Historic Preservation Design Review

September 26, 2013

HP-13-16, 25 Harby St. (City)

Request: Design Review for proposed façade renovation

Above: Existing façade prior to removal of shrubs in front

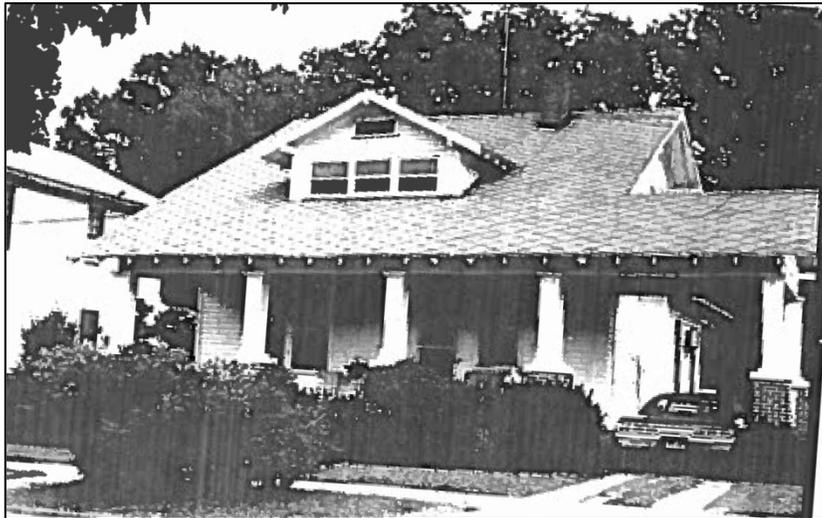
The applicant is requesting design review approval for the front and side façade renovation of the property at 25 Harby Ave.

Below: The new wall is to match the existing railing wall on the opposite side of the porch.

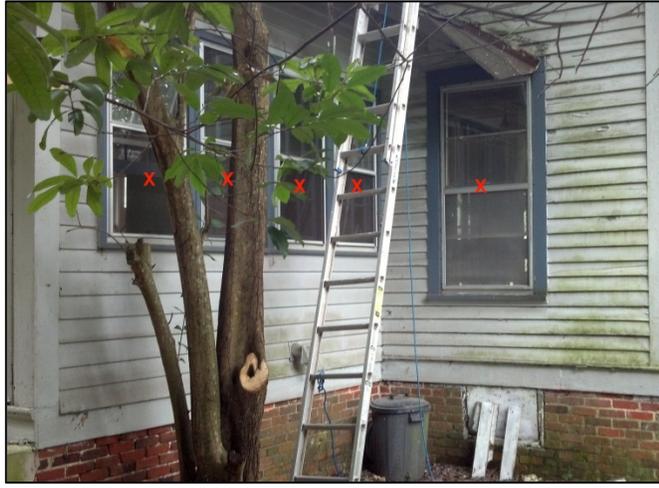
Above: The area (shown in blue) where the new railing wall will be built, if the steps are removed as proposed.

- The steps are located in such a manner as to limit use of the driveway, porte cochere and access to the rear yard.
- Staff recommends approval this request, as long as the new wall constructed on that side of the porch is built to match the opposite wall as shown in the picture below:

Precedence® Replacement Double-Hung Windows

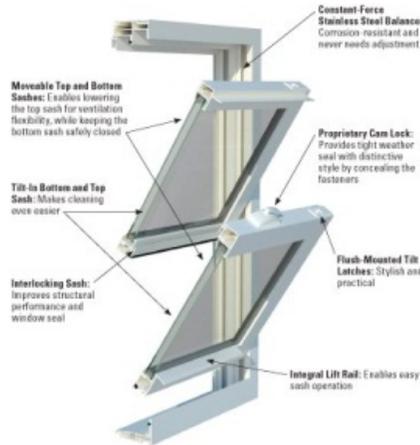
Below: The replacement windows are YKK “six over six” double hung windows with white casings.

- Staff recommends approval of the request to replace the windows on the sides and rear of the structure, because they will not be readily visible from the street.
- However, staff recommends that the original windows on the front of the house be retained, because they are “three over one” and fit the craftsman aesthetic of the house façade. The replacement windows are “six over six” and will detract from the historic character of the house.

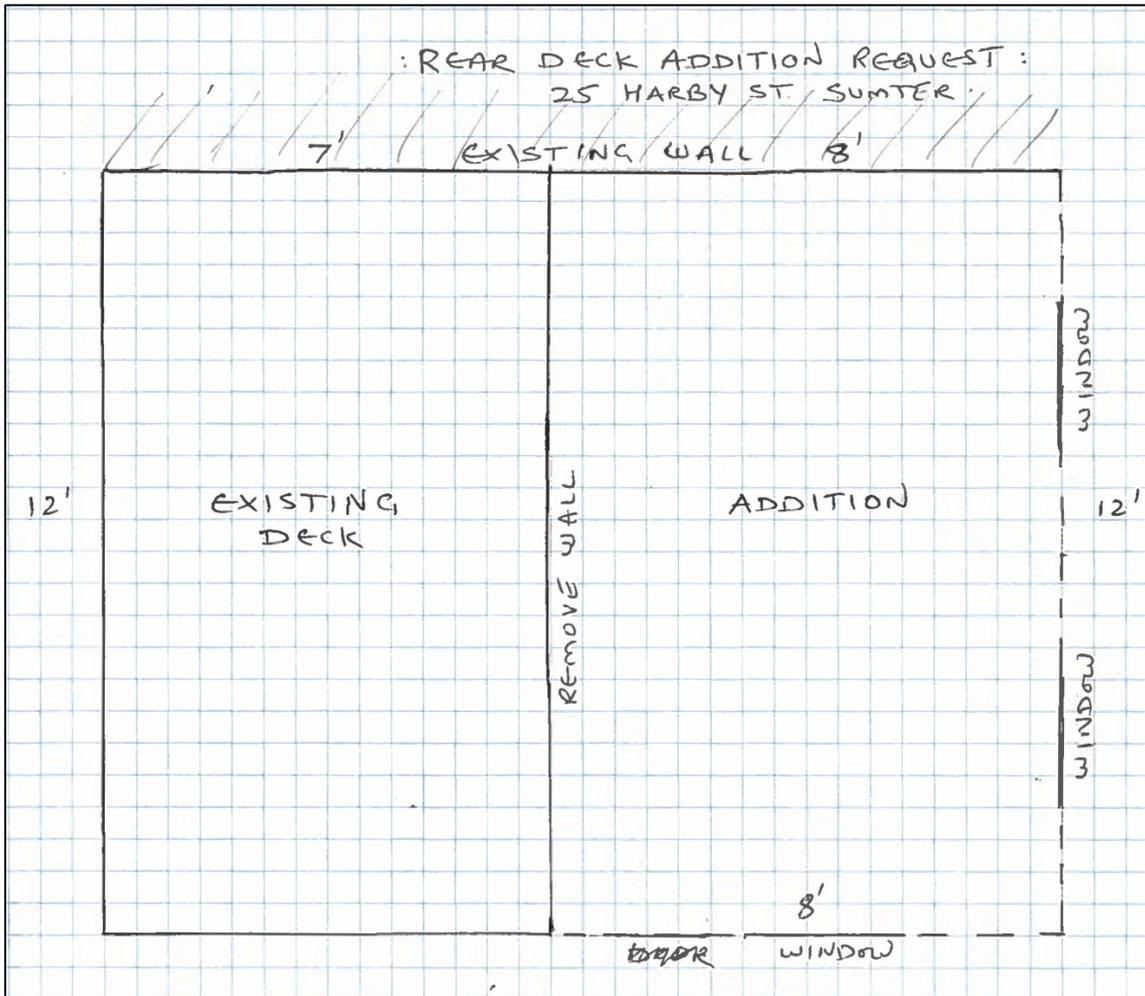
Above: The applicant is proposing a metal diverter to be placed along the front roofline (red line indicates approximate location), to divert rainwater away from the front of the house. This was proposed as an alternative to gutters, which would disrupt the architectural detailing and exposed rafters along the front of the house.

- Staff recommends approval of this because it solves the problem of rainwater at the front entrance without impacting the architectural details along the front of the house, as gutters would.
